Antares Hydraulic DCDC Control Circuit ECO

Dave Nadler (DRN)

Overview

Opto-Isolator LED Characteristics

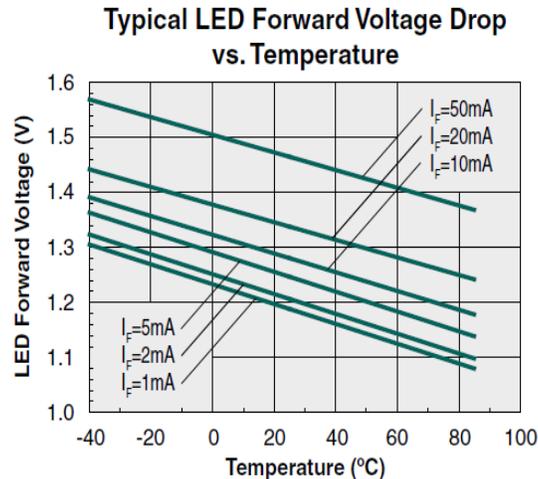
The hydraulic DCDC supply control uses an LR8 voltage source to drive two CPC1018 opto-isolators. Current production schematic v4.4 shows the two optos in series for a nominal 1.225v (LR8 2.43v divided by 2). The graph above shows 1.22v is below the 1ma curve required to turn on the opto at temperatures below 0C. While the LR8 set-point resistors are 1%, the regulator is +/- 5% or +/- .06v. **Thus in v4.4, opto switch-on is marginal and becomes increasingly unreliable at low temperatures, as the LR8 supply voltage is well below the required switch-on value.** This can be easily tested (in an Antares or on the bench) using a can of Freeze-It.

Supertex LR8K4 Linear Regulator Notes

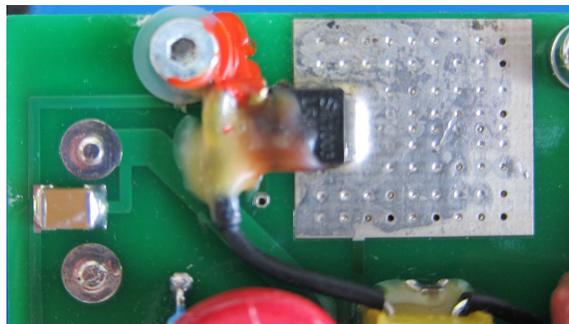
- Maximum allowable power dissipation is 2.5W, or 8.8ma at 285v.
- Operation in 20ma current-limiting mode will exceed above limit, overheat, and enter thermal limiting. Thermal limiting is at $\sim T_{\text{junction}} 125^{\circ}\text{C}$ which is the absolute maximum allowable for the LR8. **In thermal-limit mode, output current can drop to .5ma.**
- Continuous operation in the thermal-limiting modes can damage the device, or as the data-sheet nicely puts it: **“Exposure to absolute maximum rating conditions for extended periods may affect device reliability”**

V4.2 only: Excessive inrush current exceeds opto-isolator limits

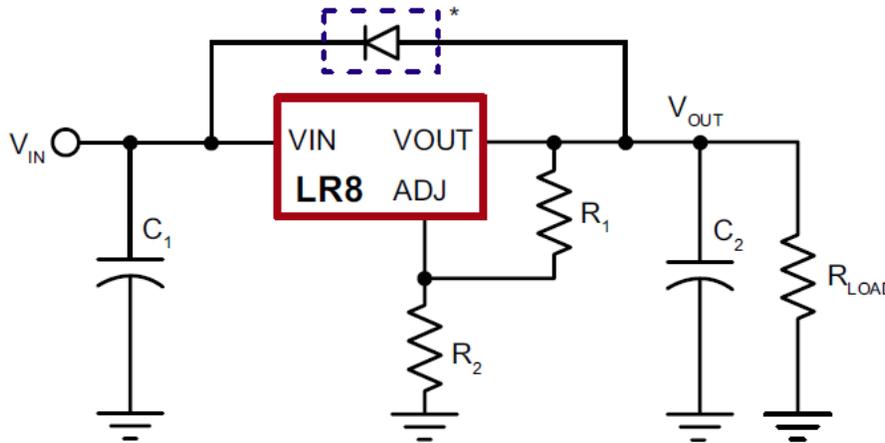
Version 4.2 sets the LR8 regulator voltage to 5.14 volts. In static operation the LR8 goes into current limiting mode with an output around 1.3v depending on temperature, then the LR8 will heat up and fall into thermal-limit mode.

However, at the instant of turn-on, the LR8's 1uF output capacitor is still charged to 5.14v, so **the initial inrush current (from the capacitor into the opto-isolators) will exceed their 50ma maximum, and may exceed the 1A-50msec limit (can damage the opto-isolators).**

Change LR8 Set-Point Resistors and LR8

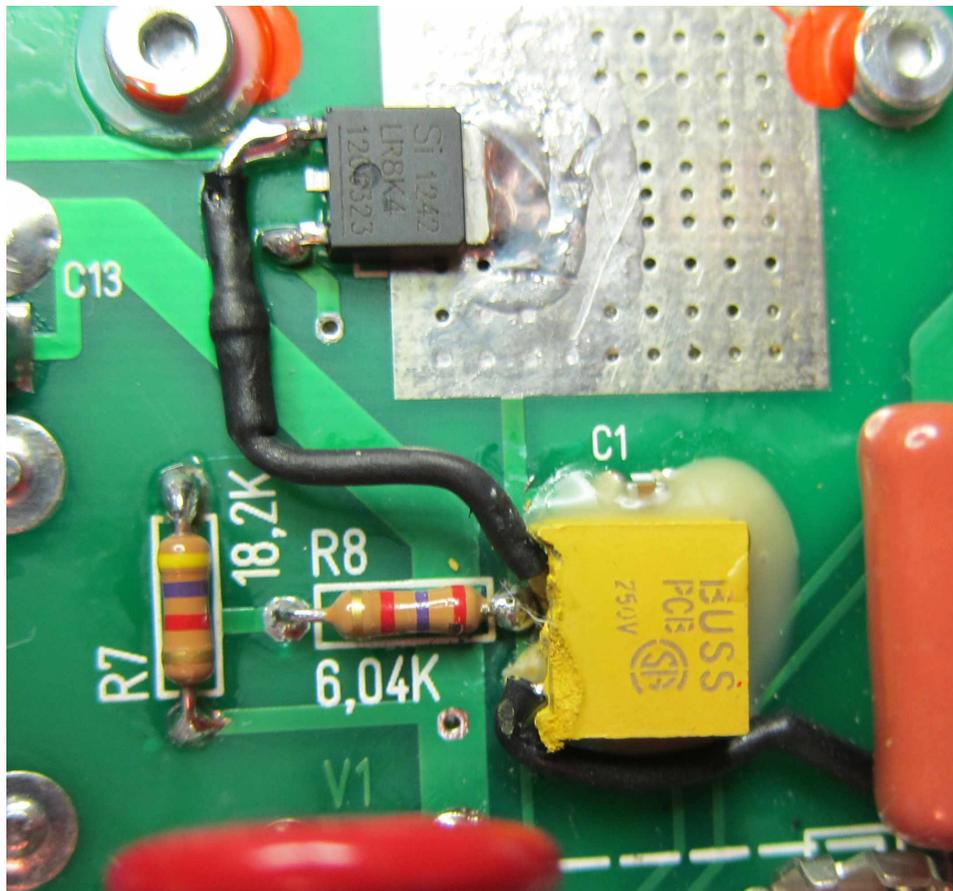
WARNING: If the fuse (yellow square above) has been badly placed with its leads very close to resistor R8 lead as above, make sure to add insulating lacquer between R8 terminal and fuse leads – fuse leads are 288 volts !!!

Change R7 to 5.11k 1%, change R8 to 2.21 1%. Bend the resistor leads and trim them very short, so there is no possibility the leads can touch the Vicor part underneath the through-holes where the resistors are installed. Replace the LR8 with a new part.

Put Opto-isolators In Series

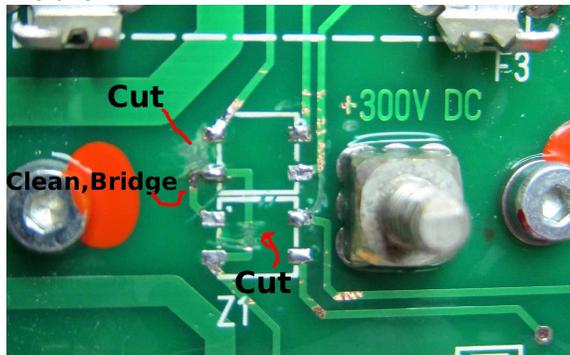
The board may have a gigantic goober of epoxy on the opto-isolators (to the left of the “300v” label), installed to try and rectify unsafe clearance between 288v input and components or traces:

Carefully remove the epoxy goober while cursing violently at whatever idiot made this mess (work slowly with hot-air soldering station to melt). Remove the opto-isolators, and clean the board, after which it should look like this:

Cut the two bridges pin1-pin1 and pin2-pin2, then clean part of the left bridge and make a solder-bridge from top pin2 to bottom pin 1, so it looks like this:

Install two new CPC 1018 opto-isolators (take care to preserve the solder bridge), and clean.

WARNING: Make sure to add insulating lacquer over opto leads and traces near 300v stud !!!
